From: Lasley, Timothy G
Sent: Thursday, August 22, 2019 11:58 AM
To: christie@woodardproperties.com; Woodard, Keith
Cc: Werner, Jeffrey B
Subject: BAR Action - August 20, 2019 - 108 West South Street

Certificate of Appropriateness

BAR 19-08-01
108 West South Street
Tax Parcel 280101000
West South Street LLC, Owner/Christie Haskin (Woodard Properties), Applicant
Elevation/Façade Alterations

**CITY OF CHARLOTTESVILLE
BOARD OF ARCHITECTURAL REVIEW
STAFF REPORT
August 20, 2019**

South Elevation

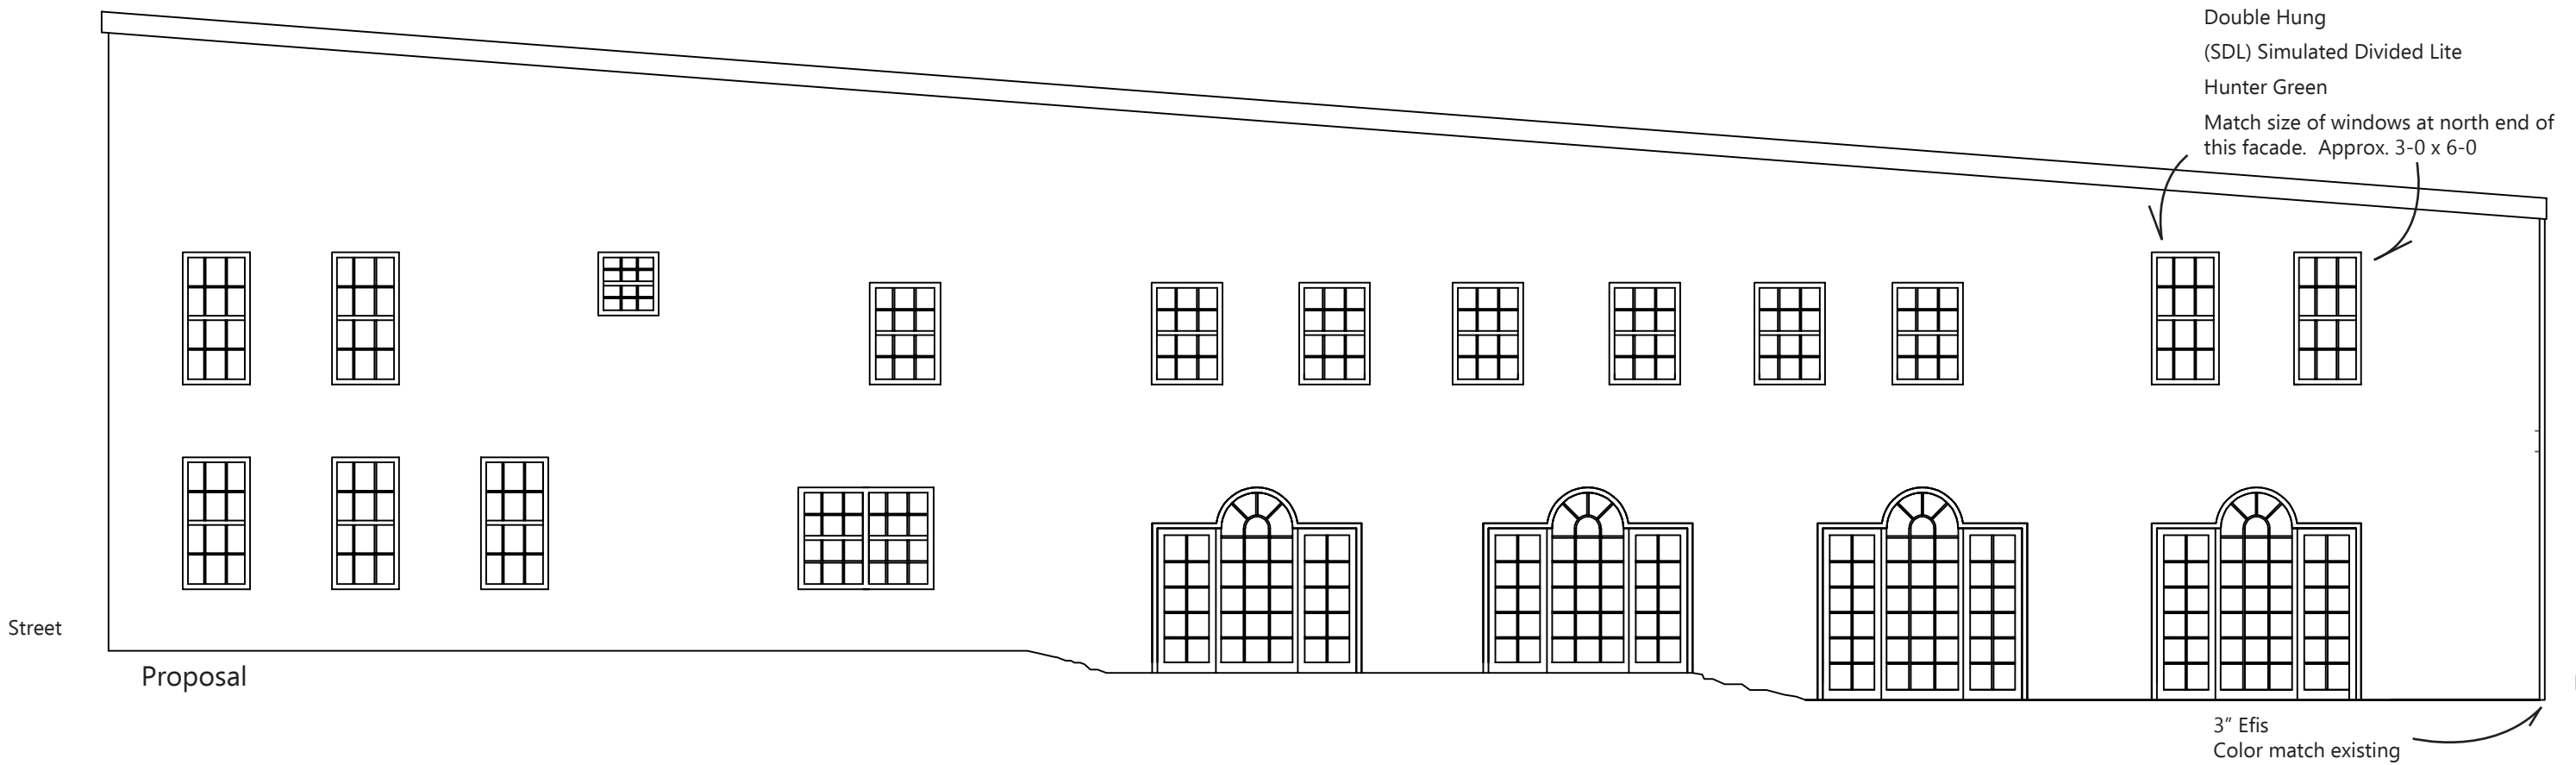
- **That new windows on the rear façade not come in contact with existing windows;**
- **That revised elevations come back for approval;**
- **The BAR recommends matching window color, but does not recommend the use of muntins in the new windows;**
- **The BAR recommends to reconsider the color of the downspouts in relation to the windows.**

Staff recommends that the existing stucco at the rear elevation be repaired in lieu of adding a 3-inch layer or material to the wall. Adding to the wall will require alterations to the trim and sills of the existing, historic windows.
